Device	SAF-C161JI-32RF, SAK-C161JI-32RF, SAF-C161JC-32RF, SAF-C161JC-32RF, SAF-C161CS-32RF, SAF-C161CS-32RF
Marking/Step	Step (E)ES-AB, AB
Package	P-TQFP-128-2

This Errata Sheet describes the deviations from the current user documentation.

Current Documentation

Figure 1 Additional Jitter

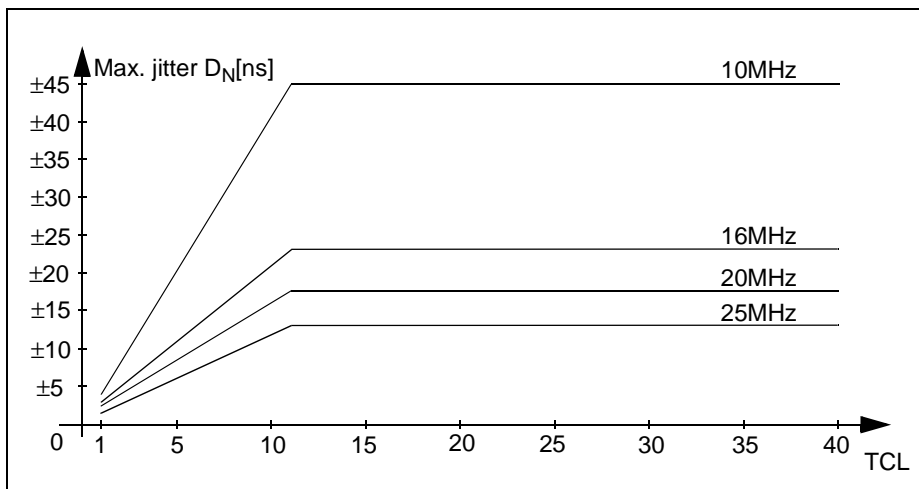
In systems where the PLL is used for generation of the CPU clock frequency, the PLL jitter can increase under certain circumstances and exceed the specified value.

The value of the additional jitter is not a fixed one but it depends on the kind of activity on the external bus or output pins. The additional jitter increases with the number of output/bus pins which are switched at the same time to a new voltage level because the problem is caused by noise on the on-chip power supply.

All PLL factors are affected (PLL factor 1.5 / 2 / 2.5 / 3 / 4 / 5). The PLL jitter increases when an access to the external bus or output pins is performed. This phenomenon has no influence to direct drive-, prescaler-, and SDD mode.

The additional jitter has the maximum effect if only one TCL is considered (period jitter). This can have an influence to the bus timings with one TCL.

The additional jitter decreases with the number of consecutive TCLs (accumulated jitter). The accumulated jitter has an effect on timings with more than one TCL (certain bus timings, CAN bus timing, serial interfaces).

For an accumulated period of $N \cdot \text{TCL}$ the new maximum jitter $D_N[\text{ns}]$, which exceeds the specified value in the Data Sheet, is computed using the formula:

$$D_N[\text{ns}] = \pm[(50 / f_{\text{CPU}} + 164 / f_{\text{CPU}}^2 - 0.04) * (N / 2 - 1) + 1180 / f_{\text{CPU}}^2 + 0.2]$$

For all accumulated periods longer than 12 TCL the $N=12$ value can be used; see figure below.

In case that the additional jitter causes problems in the system which cannot be relaxed with software adapted timing parameters, then direct drive or prescaler mode can be used. If the maximum frequency of the on-chip oscillator (16 MHz) is not sufficient then an external clock generator can be used.

Figure 2 C161CS/JC/JI-32RF Clock Configuration

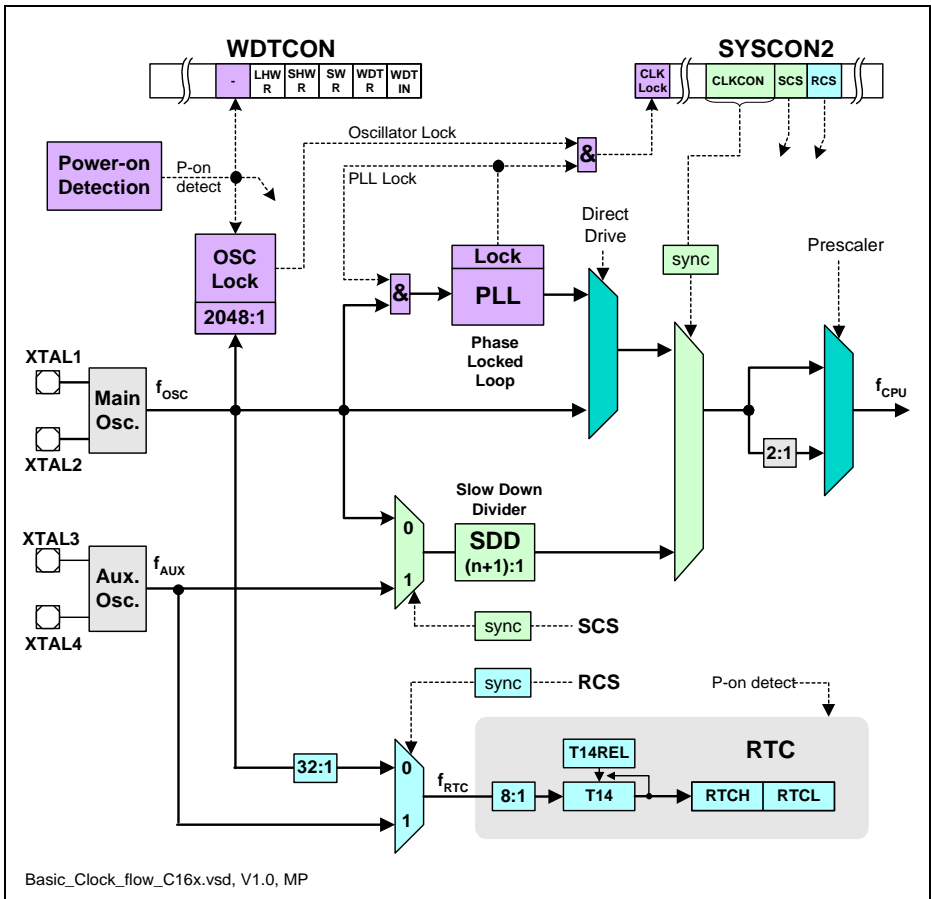
For the modification of the internal clock multiplexer controlled via SCS or RCS in register SYSCON2 a clock pulse from XTAL3 is required. The register contents SCS and RCS can be modified without a clock pulse from XTAL3 but this has no effect on the system because SCS and RCS are synchronized with XTAL3.

- When the system is running in direct drive or PLL clock mode, it is not allowed to switch the clock path to SDD mode via software because if SCS = 1 (modification via software has no effect on the clock multiplexer) then the system gets no clock.
- When SYSCON2.RCS = 1 the RTC will stop (modification via software has no effect on the clock multiplexer).

Consider the conditions to get a defined clock configuration at power-on.

Figure 3 SSCTB Timing

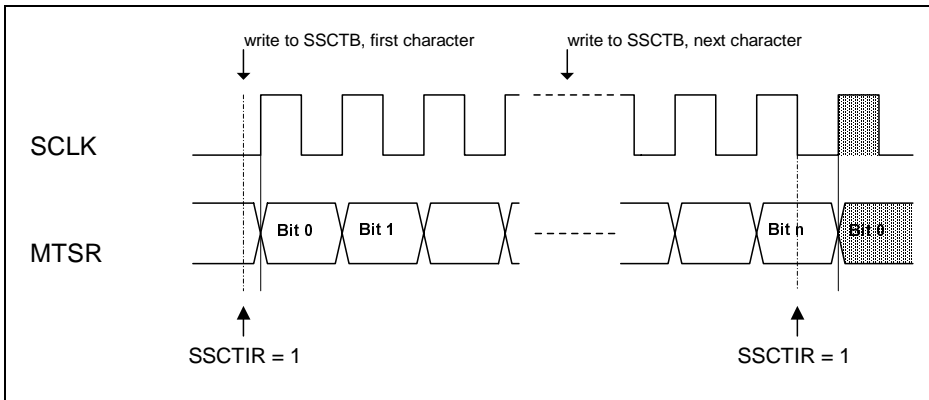
- When SSCTB has been written while the transmit shift register was empty (and the SSC is enabled), flag SSCTIR is set to '1' directly after completion of the write operation, independent of the selected baud rate. When the transmit shift register is not empty when SSCTB was written, SSCTIR is set to '1' after the last latching edge of SCLK (= 1/2 bit time before the first shifting edge of the next character). See also e.g. C167CR User's Manual V3.1, p. 12-5.

The following diagram shows these relations in an example for a data transfer in master mode with SSCPO = 0 and SSCPH = 0. It is assumed that the transmit shift register is empty at the time the first character is written to SSCTB:

Typically, in interrupt driven systems, no problems are expected from the modified timing of flag SSCTIR. However, when flag SSCTIR is polled by software in combination with other flags which are set/cleared at the end or at the beginning of a transfer (e.g. SSCBSY), the modified timing may have an effect.
